Amendments to the Drawings

The attached sheets of drawings include changes to Figure 1. This sheet, which includes Figure 1, replaces the original sheet including Figure 1.

FIG. 1

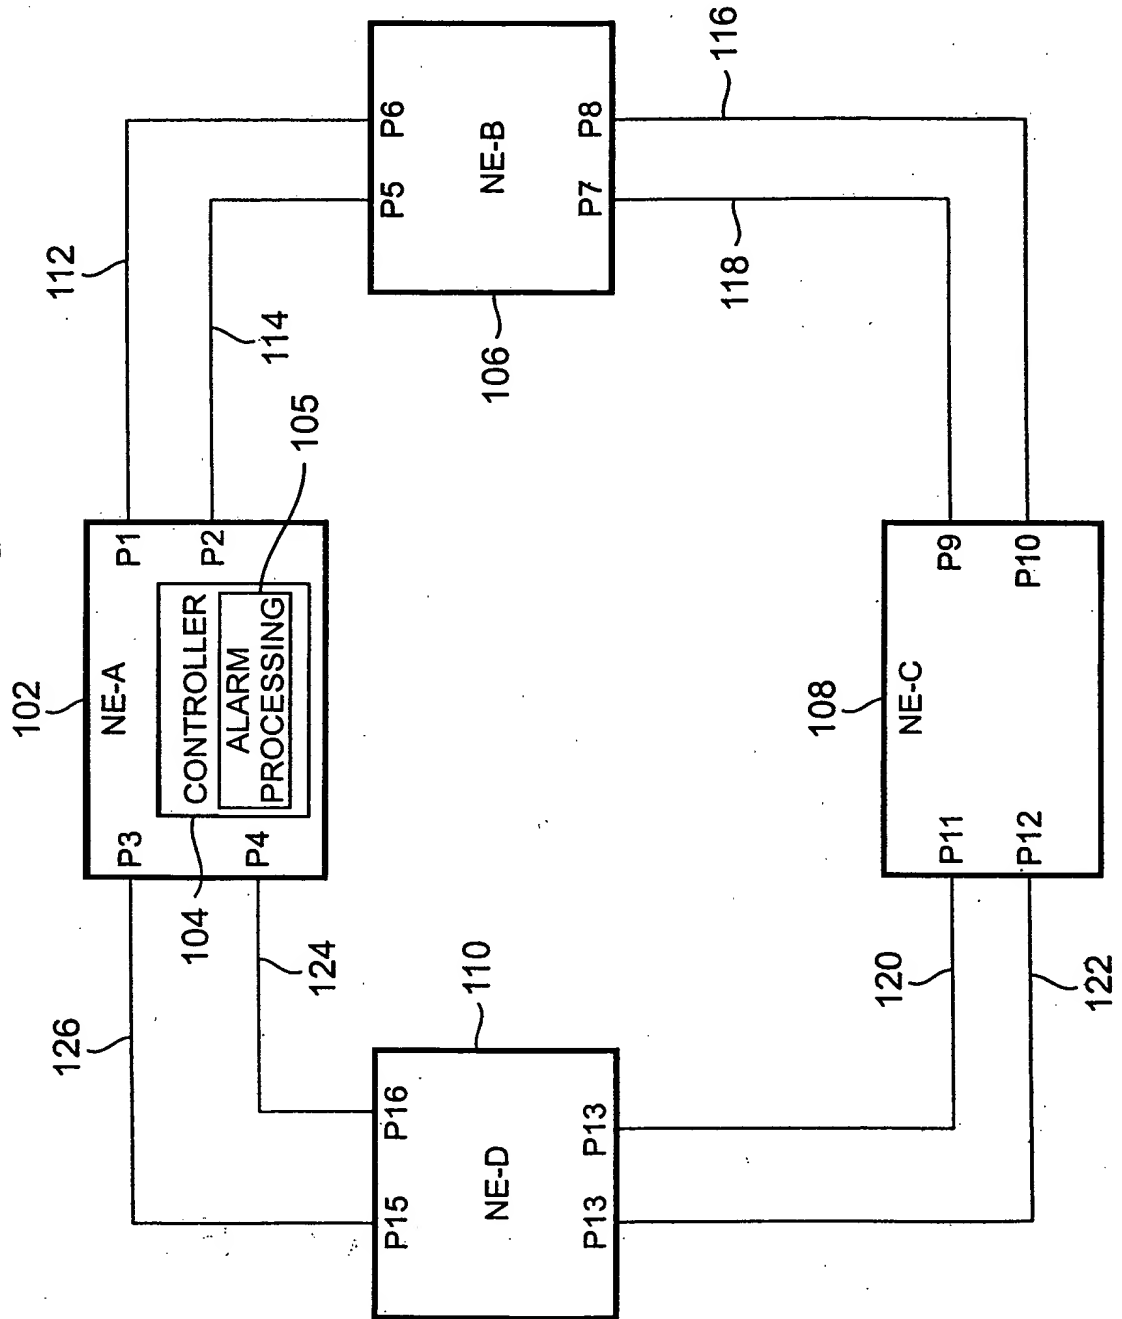
In Figure 1, a block depicting the alarm processing of the present invention, a descriptive label for the added block, and a reference number for the alarm processing block have been added.
